LASALLE COUNTY STATION UNIT 1

TECHNICAL SPECIFICATION CHANGE REQUEST

NPF-4/82-11

Subject: Unit 1 RCIC Flow Test at Steam Pressure 150 ± 15 psig.

FIG 1

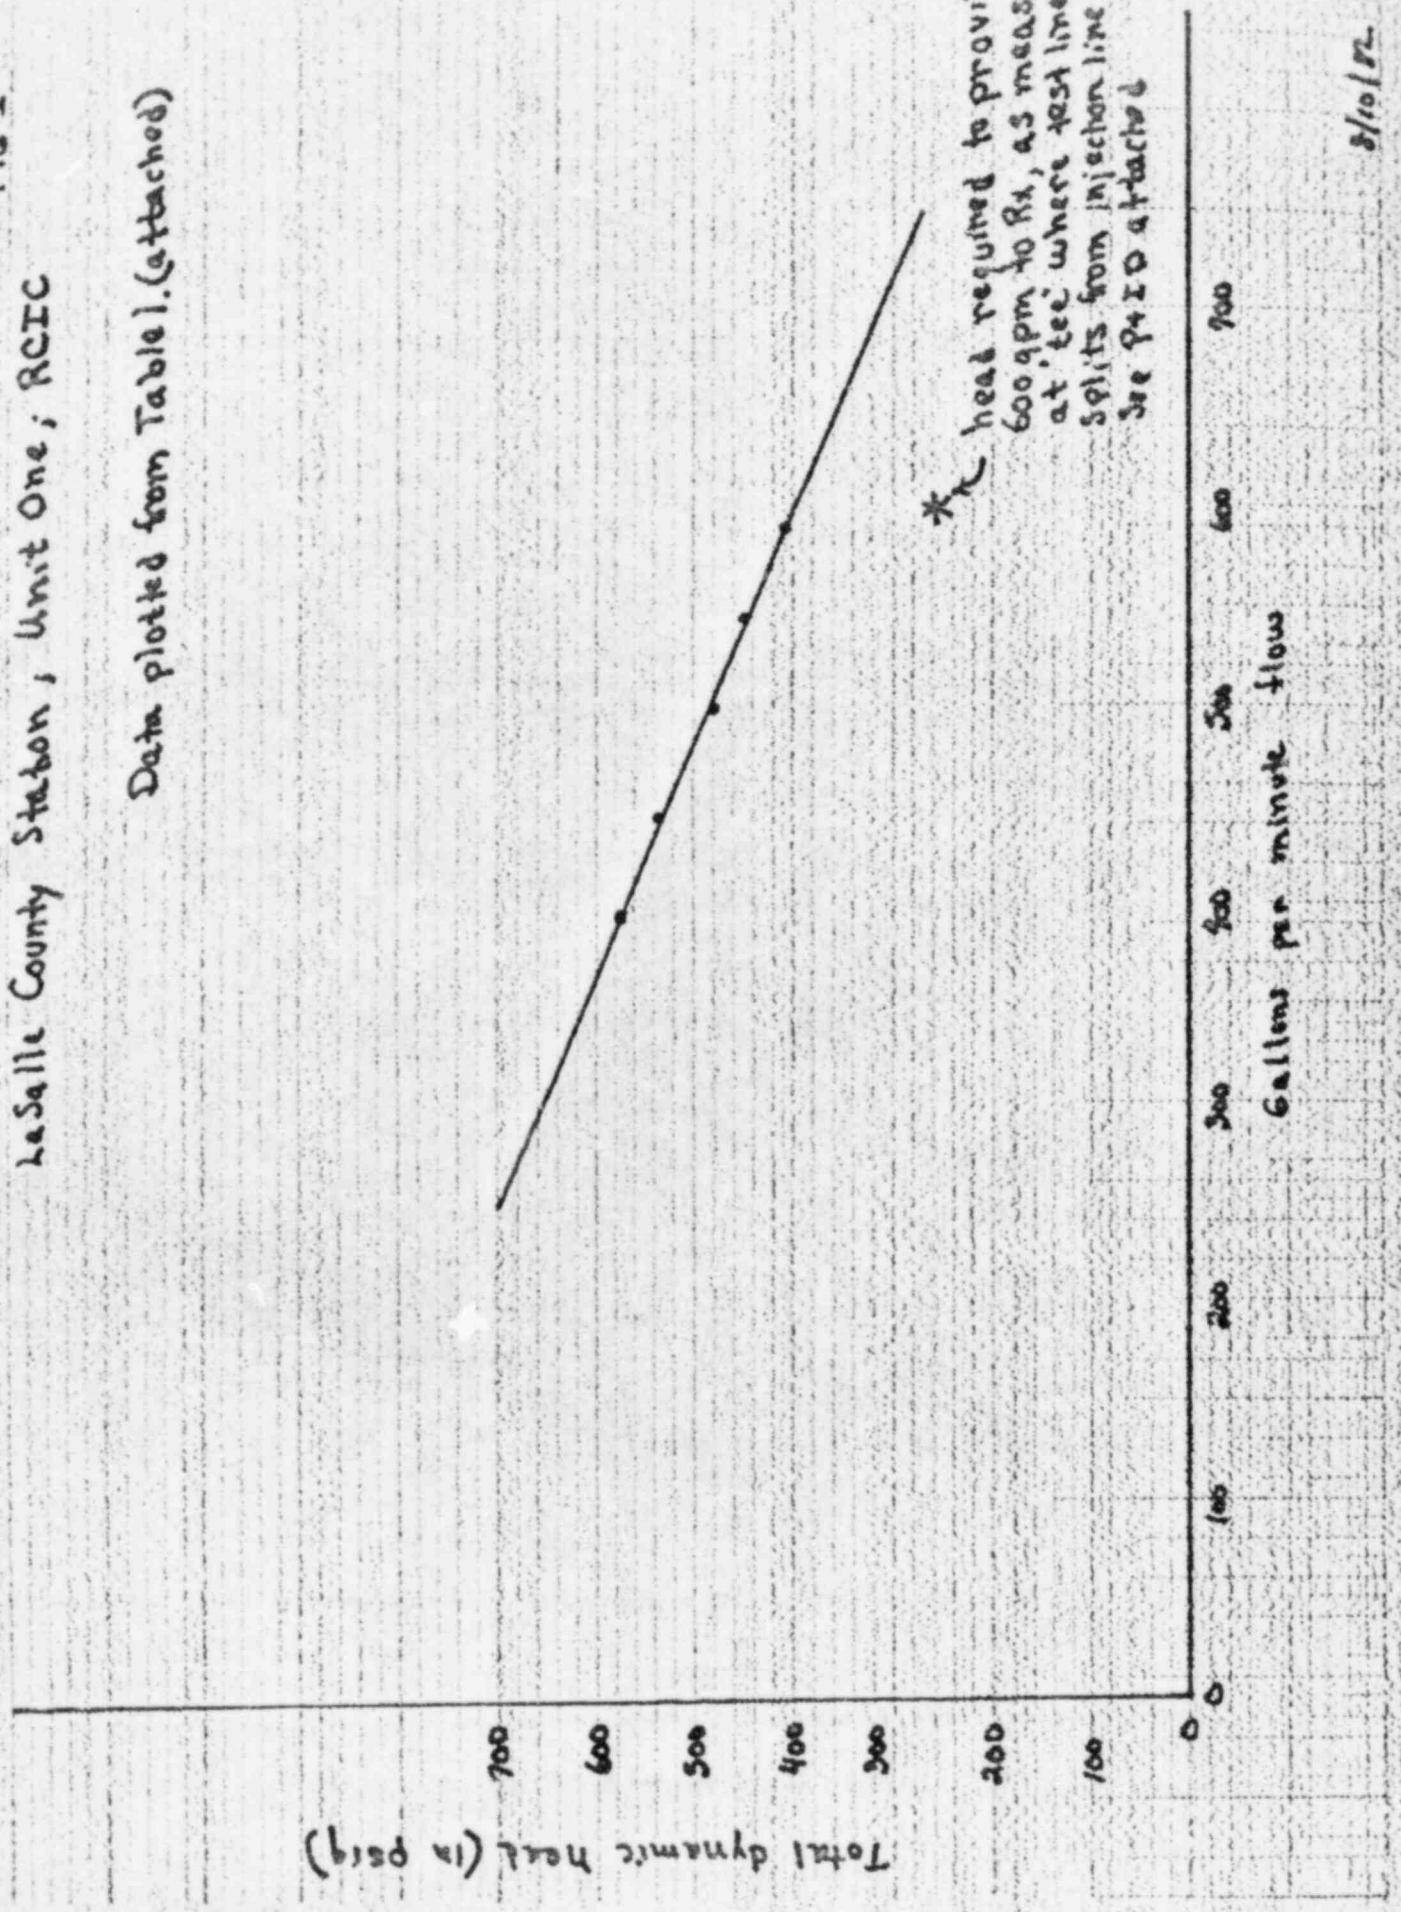
Initial Startup Test data in Table 1 and plotted on Figure 1 indicates the current test line permits on 590 gpm flow at a discharge pressure of 430 pounds. Line losses, as calculated in References (a), (b), and (c) indicate that a pressure of 258 psig or greater at the Test Line will ensure a flow of 600 gpm into the reactor vessel at a reactor pressure of 165 psig. The equivalent pressure at the "T" at 590 gpm is 416 psig. Therefore, from Table 1 and Figure 1 it can be demonstrated that approximately 150 psig excess (416-258) is available for injection to the vessel. Actual Startup Test data will be taken to determine the vessel injection line loss and flow capacity.
